DUCKWORTHS
ARBORICULTURE

Arboricultural Supervision & Site Inspection

Location: Carnival Place, Wellington Road, Wokingham, Berkshire RG40 2AF

Date of visit: 4th March 2025

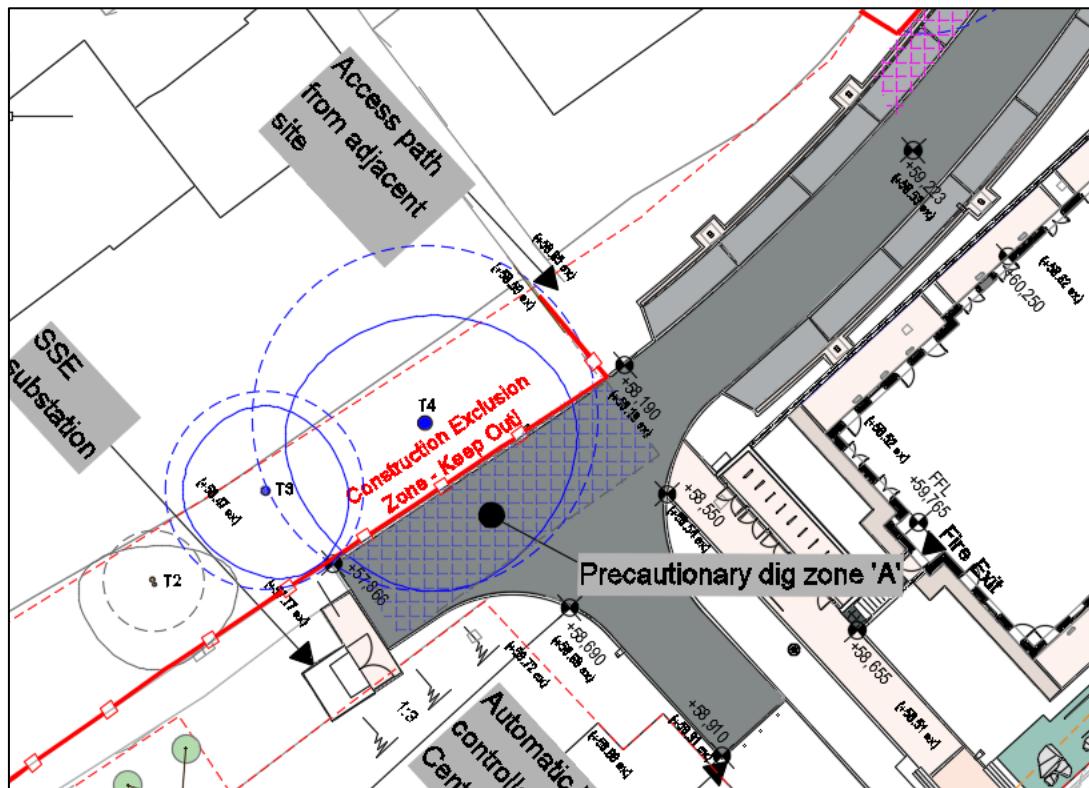
A pre-arranged site visit was undertaken to meet the Arboricultural Contractors ahead of the facilitative tree works to remove low grade trees along the northwest boundary and to raise the canopies of the protected trees where they overhang the new parking spaces.

The tree surgeon is Mr. Tom Pirton. At the meeting we walked the length of the treed boundary and agreed on site each individual tree to be removed. I also showed him on site which trees are subject of a TPO.

It was confirmed that works to the TPO trees would be the minimum required to create necessary clearance over the parking spaces.
